NP-11-0029
July 8, 2011

Subject: Exelon Nuclear Texas Holdings, LLC
Victoria County Station Early Site Permit Application
Response to Request for Additional Information Letter No. 10
NRC Docket No. 52-042

Figure 2.5.4-1 Subsurface Investigation Location Plan (Power Block Area) (Representative Dual Unit ESBWR Layout Shown)

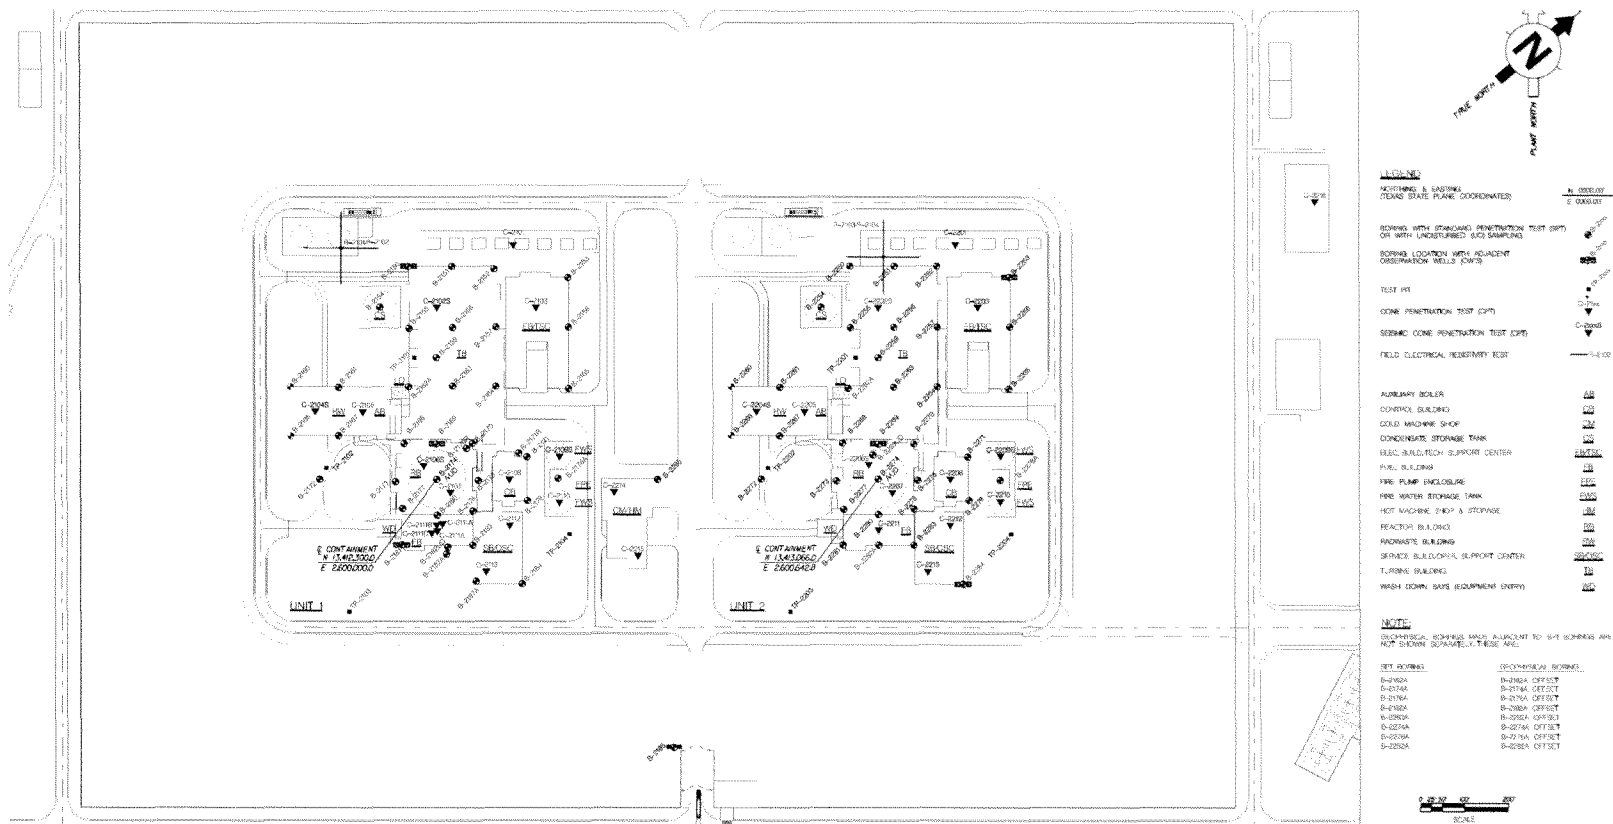
- a) SSAR Subsection 2.5.4.2.2.1 states that the sampling intervals for the subsurface investigation borings vary from guidance provided in RG 1.132. Please quantify and explain these variations.
- b) The staff was not able to locate C-2106, C-2204SA, and C-2206, B-2162A, B-2176A, B-2182A, and B-2282A in Figure 2.5.4-1. Please clarify where these borings are located.

C-2106 and C-2106S (CPT with seismic readings) were performed within 6 ft of each other. Since the inverted triangle CPT symbol on SSAR Figure 2.5.4-1 is about 20 ft wide, only the C-2106S symbol and number were put on the drawing to preserve visual clarity.

C-2204S was planned as a 100 ft deep seismic CPT. It refused at a depth of 55 ft. C-2204SA, located about 7 ft from C-2204S, was a second attempt to reach 100 ft depth. It refused at a depth of 91 ft. C-2204SB, located approximately 11 ft from C-2204S, was a third attempt to reach 100 ft depth. It refused at a depth of 90 ft. Since the inverted triangle CPT symbol on Figure 2.5.4-1 is about 20 ft wide, only the C-2204S symbol and number were put on the drawing to preserve visual clarity.

C-2206 and C-2106S (CPT with seismic readings) were performed within 16 ft of each other. Since the inverted triangle CPT symbol on Figure 2.5.4-1 is about 20 ft wide, only the C-2206 symbol and number were put on the drawing to preserve visual clarity.

B-2162A is mislabeled as B-2162 on Figure 2.5.4-1. The label on the Figure 2.5.4-1 will be changed to B-2162A.

B-2176A is mislabeled as B-2176 on Figure 2.5.4-1. The label on the Figure 2.5.4-1 will be changed to B-2176A.

B-2182A is shown on Figure 2.5.4-1, just south of the Unit 1 Fuel Building.

B-2282A is mislabeled as B-2282 on Figure 2.5.4-1. The label on the Figure 2.5.4-1 will be changed to B-2282A.

SSAR Figure 2.5.4-1 will be modified in a future revision of the ESPA to change the labels B-2162, B-2176 and B-2282 to B-2162A, B-2176A and B-2282A, respectively, as indicated.

Figure 1: Subsurface Profile (Typical LWR with an Independent UHS)
(Elevations in NAVD 88)

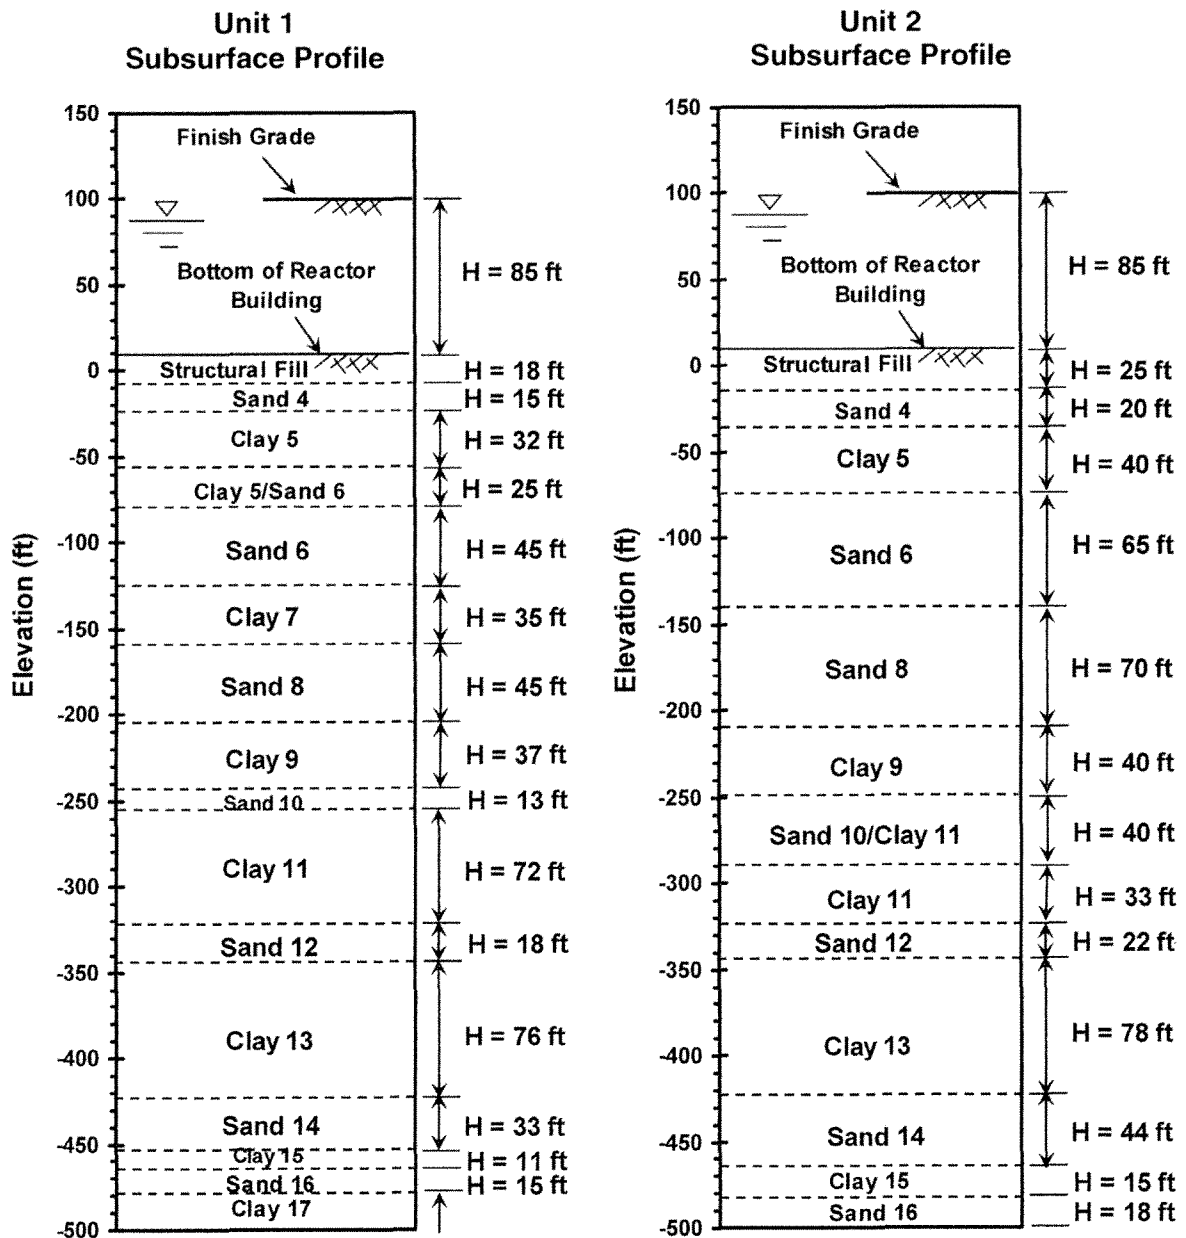
SSAR Subsection 2.5.4.5.1.1.1 states that the upper soils of Clay 1 through Clay 3 will be excavated. Figure 2.5.4-131 shows Clay 3 under structural fill. In accordance with 10 CFR 100.23(d)(4), explain this discrepancy.

The first sentence of SSAR Section 2.5.4.5.1.1.1 indicates a typical dual-unit LWR with an independent UHS is the bounding configuration, when considering excavation and backfill quantities. The “typical” design from which these excavation and backfill quantities are derived is the ABWR plant. SSAR Figure 2.5.4-131 shows the subsurface profile for the reactor/fuel building for a typical LWR with an integral UHS. The “typical” design from a bearing capacity settlement standpoint is the ESBWR plant.

The ABWR was selected as the bounding configuration from an excavation and backfill standpoint because the reactor building foundation basemat is 85 ft below grade, which is deeper than all of the other designs being considered except mPower. Because mPower is a small modular reactor (and has a smaller footprint than the other designs being considered), there is less excavation involved for an mPower unit than an ABWR. Figure 1 is the ABWR equivalent to SSAR Figure 2.5.4-131. Finish grade is El. 95 ft, and the bottom of the reactor foundation is El. 10 ft. In Unit 1 (i.e., the western portion of the power block area), Clay 3 starts at El. 20 ft and stops at El. -8 ft. All elevations are referenced to NAVD 88. As shown in Figure 1, the Clay 3 is removed and replaced with structural fill below the foundation base. In Unit 2 (i.e., the eastern portion of the power block), Clay 3 starts at El. 18 ft and stops at El. -15 ft. Similarly, the Clay 3 is removed and replaced with structural fill below the foundation base. Thus, the statement in SSAR Section 2.5.4.5.1.1.1 about removing Clay 3 from beneath the representative LWR (with an independent UHS), that is the ABWR, is correct for the purposes of determining bounding excavation and backfill quantities.

The ESBWR was selected to illustrate bearing capacity and settlement because, although it has similar plan dimensions and total applied bearing pressure to the ABWR, the base of the reactor/fuel building combined foundation mat is almost 20 ft shallower than the ABWR reactor building. Thus, the ESBWR experiences less buoyancy effects and is founded on soils that are nearer the surface, which generally implies they are less stiff or dense. Bearing capacity calculations show that if Sand 2 and Clay 3 below the base of the reactor/fuel building foundation mat, at about El. 29 ft, were excavated down to El. 8 ft (i.e., 21 ft of over-excavation) and replaced with structural fill, then the relatively thin layer of Clay 3 remaining below the structural fill would provide sufficient bearing capacity and would not contribute excess settlement.

In summary, SSAR Subsection 2.5.4.5.1.1.1 is correct in that the upper soils of Clay 1 through Clay 3 will be excavated based on an ABWR design. Figure 2.5.4-131 is correct in that for the ESBWR design all of Clay 3 is not excavated. This information will be updated, as required, at the COL stage when a specific reactor technology is selected.
